A. Statement of Technical Rationale and Justification

B. Text of Regulations

Figure 1 : Illustration of Ambient Altitude and Temperature Conditions [figure to be revised by EPA]

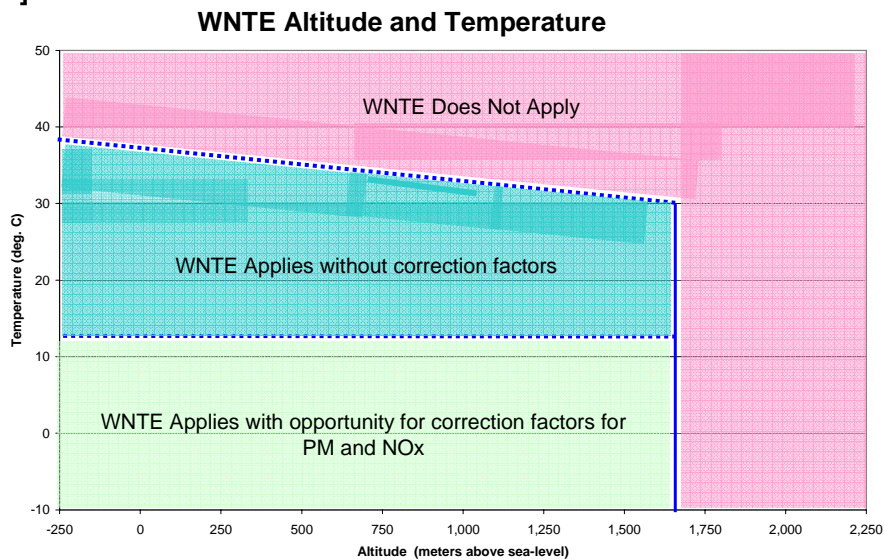
- all engine coolant temperatures within the range of 343 K to 373 K (70°C to 100°C).**[EPA to check consistency w NTE parameter]**

Figure 2: Example Not-To-Exceed Control Area When C Speed < 2,400 rpm

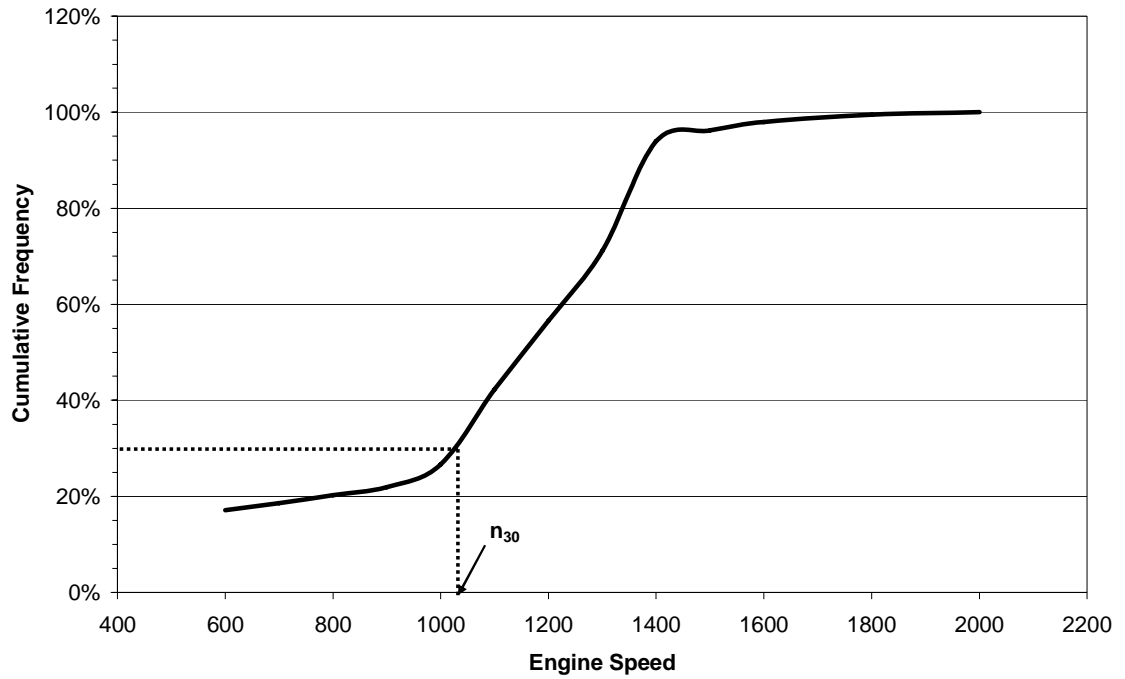
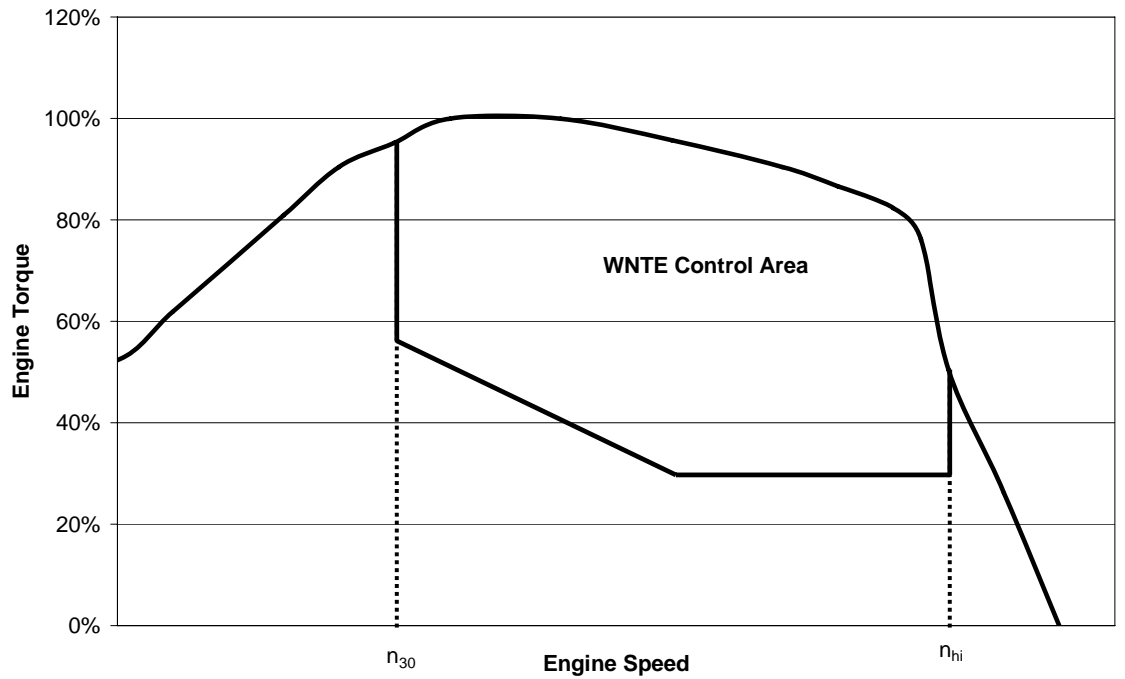
Editorial Comment: Will insert WNTE control area speed and load diagram for engines with PM below "x g/kW-hr" in this location

Editorial Comment: Will update diagrams to correspond with final control area established in gtr and will add example figures without PM carve out.
